November 4, 2015

IGES Project No. 02132-002

Subject: Response to Additional Review Comments - Geology  
Geotechnical Investigation Report  
Lot 39R of Powder Mountain Resort  
8365 East Summit Pass  
Weber County, Utah

FIGURE 1

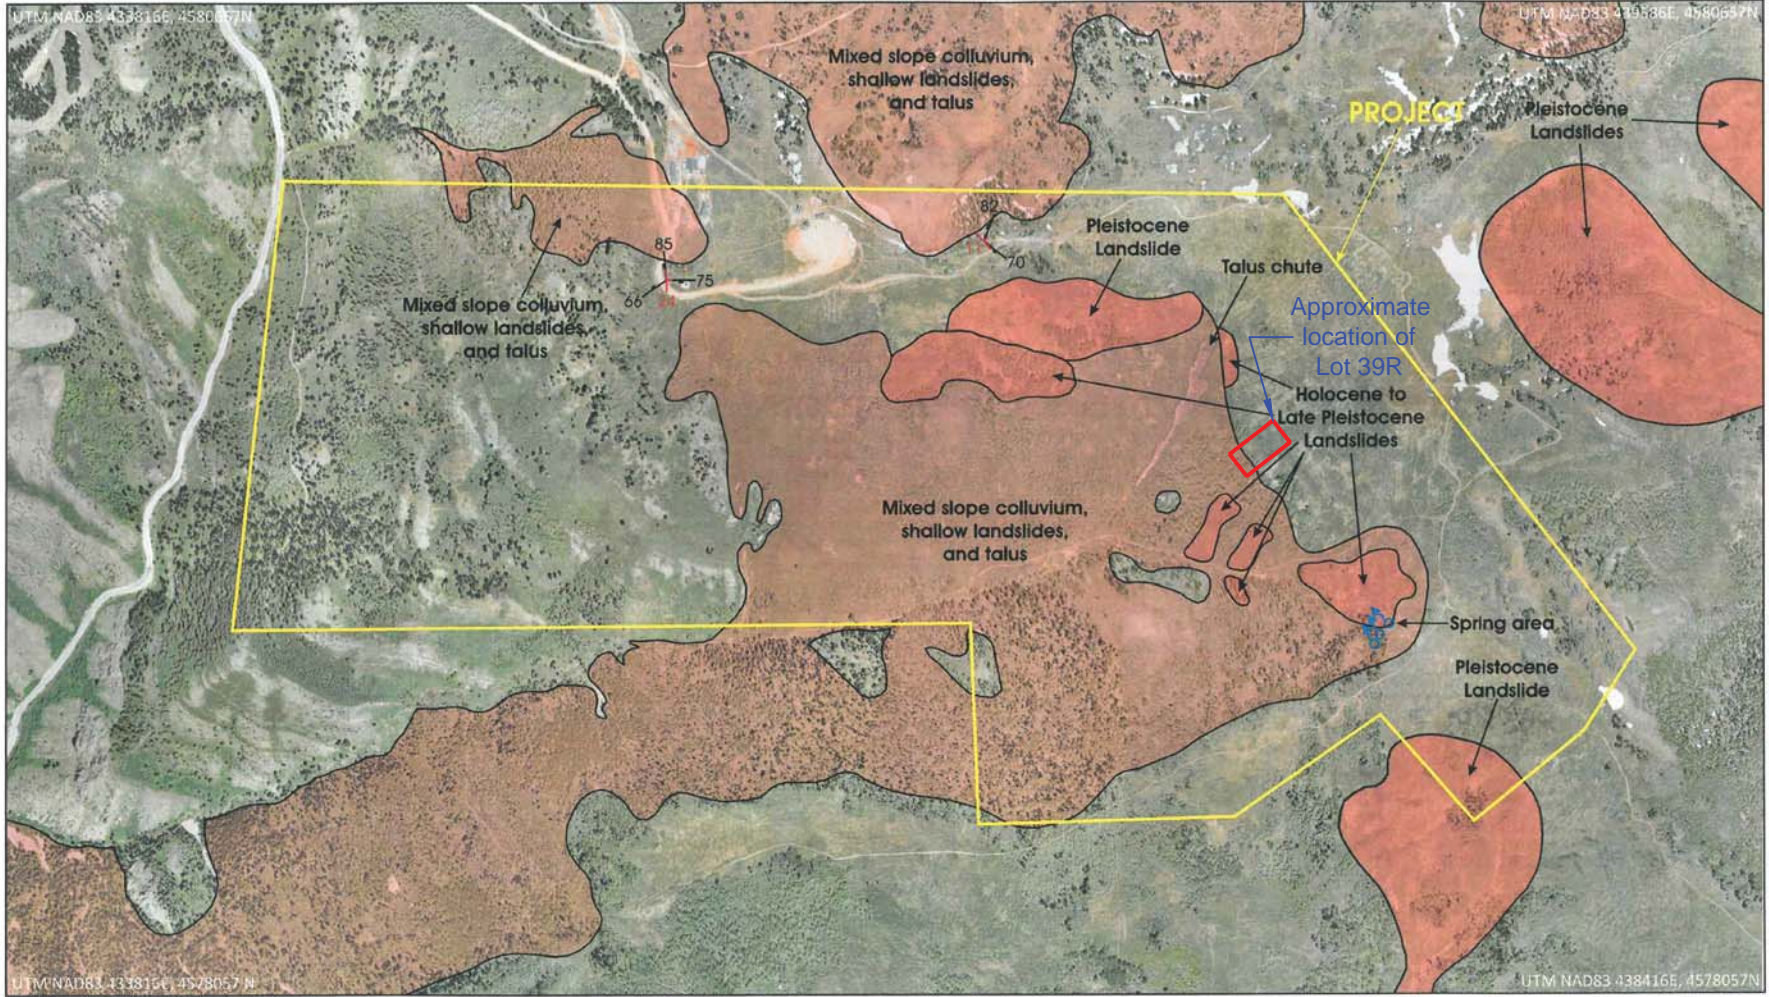
*“SA recommends Weber County request IGES provide Figure 3 of Western GeoLogic, 2012, report depicting the location of the subject site and noting “... the Holocene and Late Pleistocene landslide deposits to the west and south of the subject property.”*

**Response to Comment No. 2b**

Figure 1 attached reproduces Figure 3 of the Western GeoLogic (2012) report, with the approximate location of Lot 39R also shown. As seen in the figure, Western GeoLogic identified six Holocene to Late Pleistocene landslides (arrows extending from the “Holocene to Late Pleistocene Landslides” label point to the individual landslide deposits) at various locations northwest to southeast of the subject property.

**FIGURE 2**

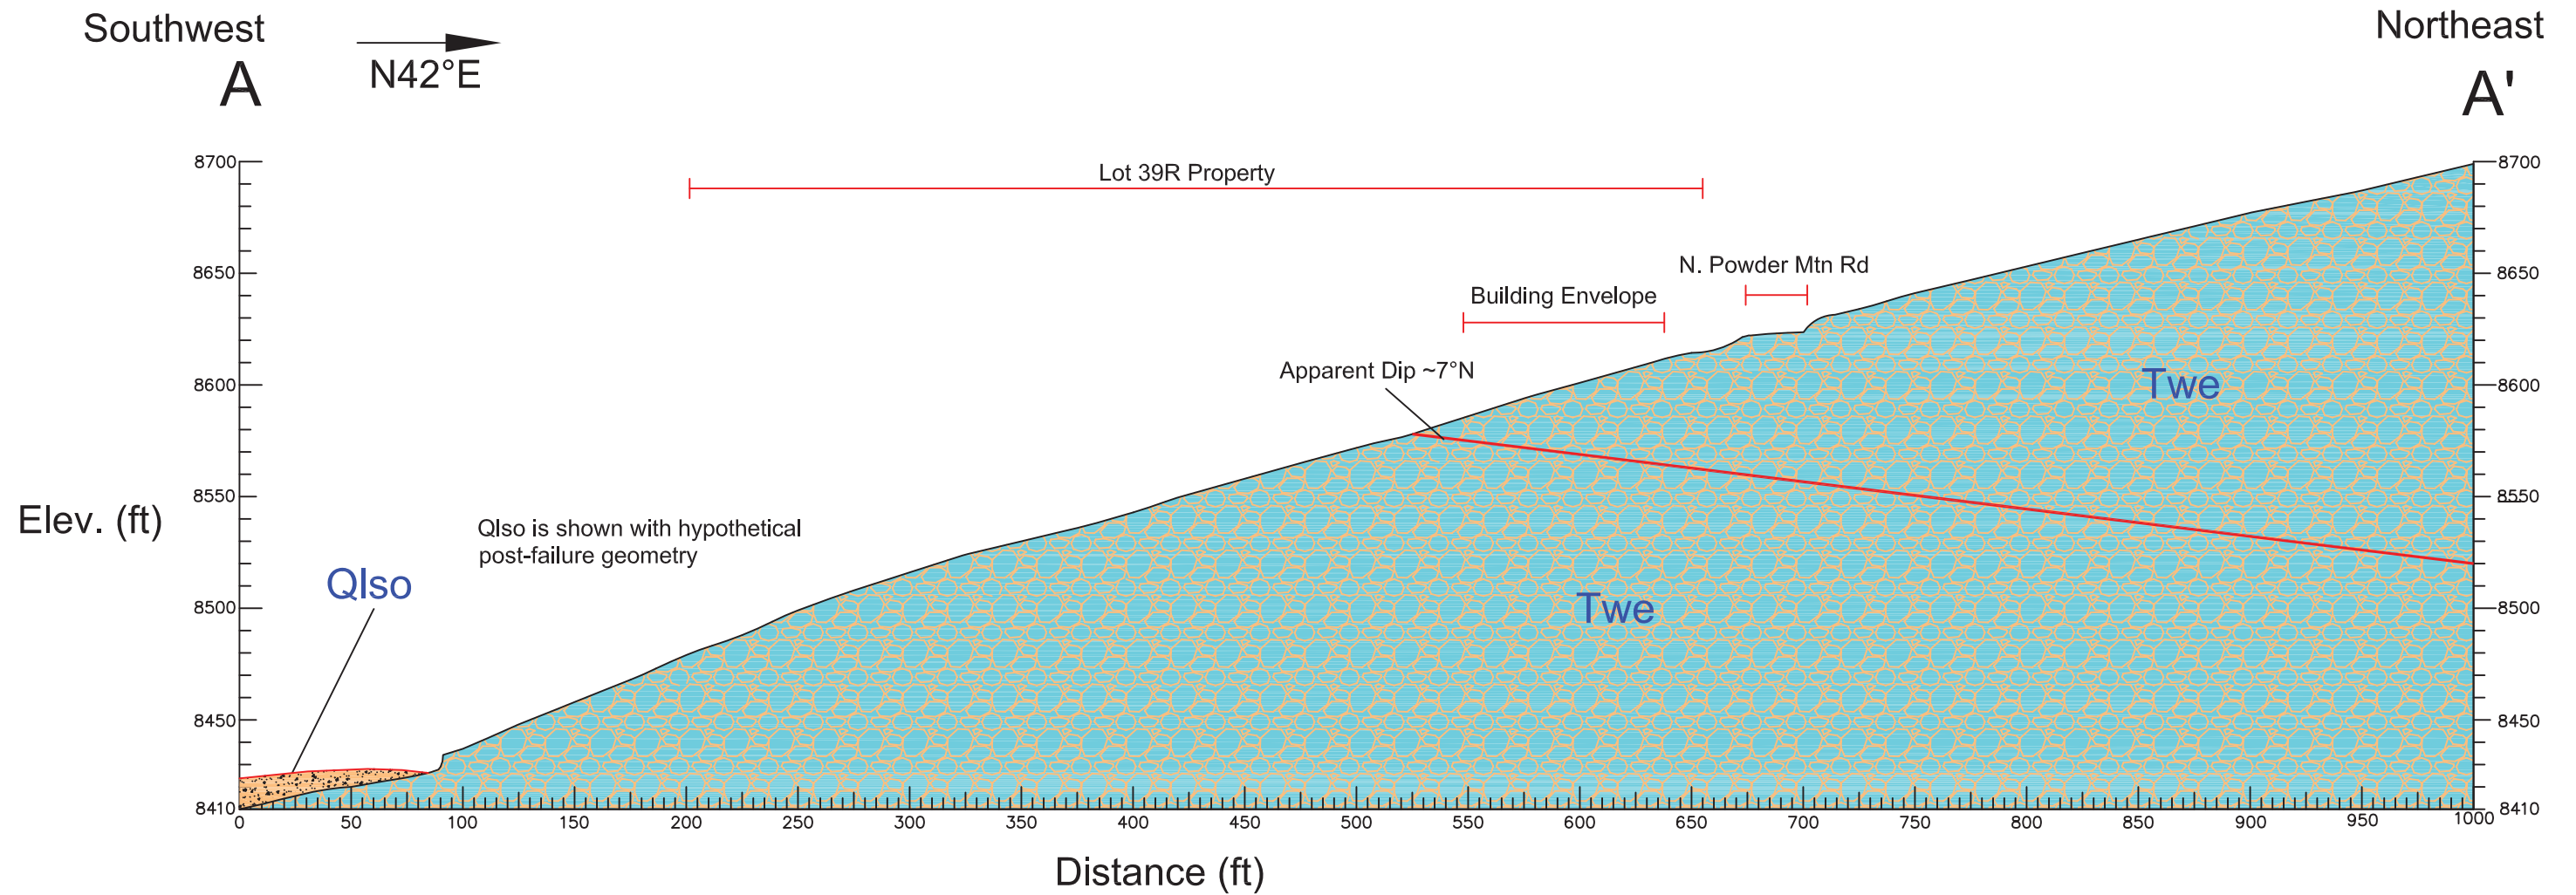
*“Provide the data/evidence which forms the basis for their conclusion that the 450 foot setback of the building envelope from the landslides is an “...acceptable setback...”*

The stability of the slope was modeled using gSTABLE7 slope stability software. Bishop’s Simplified Method was used to model the slope. Calculations for stability were developed by searching for the minimum factor-of-safety for a circular-type failure. A minimum static factor-of-safety of 1.5 and seismic factor-of-safety of 1.0 was considered acceptable for this project considering the available information. Homogeneous earth materials (existing site soils, colluvium) and arcuate failure surfaces were assumed. The section analyzed is Section A-A’, illustrated on Figure 1 in the first IGES review response (IGES, 2015c). For convenience, Figure 1 from the first response is included as an attachment to this letter, presented as Figure 2.

Based on our analysis, in a hypothetical post-failure condition, minimum factors-of-safety of 1.5 and 1.0 for static and seismic conditions, respectively, are maintained with respect to the proposed building envelope. Therefore, the distance between the proposed building envelope and the mapped landside is considered acceptable from a slope stability and geologic hazard standpoint. The results of the global stability analyses are attached.
